In the Matter of  
Philadelphia Electric Company  
(Limerick Generating Station, Units 1 and 2)  
Docket Nos. 50-352 and 50-353

This letter is being submitted in response to the Atomic Safety and Licensing Board's "Order Regarding Quality Assurance Documents" (May 13, 1983). Attachment 1 is a copy of NRC I&E Inspection Report No. 50-353/76-06, including the related Notice of Violation. Attachment 2 is Applicant's response thereto which is a letter from V. S. Boyer to J. P. O'Reilly dated December 15, 1976 with three attachments of which only the first is relevant to the matter raised by Mr. Romano. Attachment 3 is a December 29, 1976 letter from R. T. Carlson to V. S. Boyer acknowledging receipt of Mr. Boyer's December 15, 1976 letter. Counsel for the Staff has reviewed these three documents and agrees that they are accurate copies of the inspection report and letter sent by it and Mr. Boyer's letter received by it.

IE Inspection Report No: 50-353/76-06 Docket No: 50-353  
Licensee: Philadelphia Electric Company License No: CPPR-107  
2301 Market Street Priority: --  
Philadelphia, Pennsylvania 19101 Category: A  
Safeguards  
Group: --  
Location: Limerick, Pennsylvania  
Type o

1 PAGE 2 OF 254 Δ 14. NCH NO. 1920

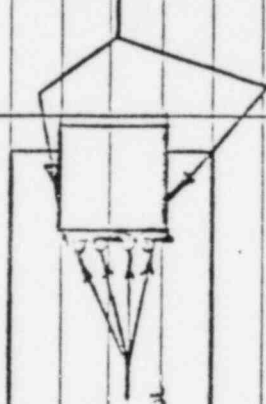
Block #19 Cont: And Unacceptable Due to Excessive Undercutting and Incomplete Welding of the Connection Angle to the Beam Web. This is Contrary to the 1970 Edition of the AISI Code - Part 4 Revised 6-73 and AWS D1.1-73, R1-73 and R2-74 Editions.

## FIELD RECOMMENDATION - TO PROJECT ENGINEERING (REVISED)

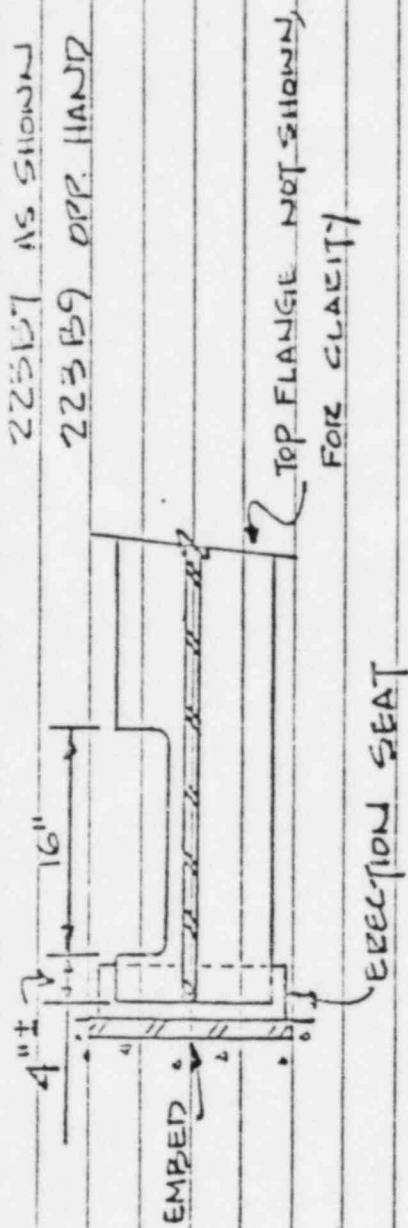
WHILE REPAIRING THE TWO BEAMS, CORES WERE MADE INTO THE BOTTOM FLANGES AS SHOWN.

FIELD RECOMMENDATION TO LEAVE BEAMS AS IS.
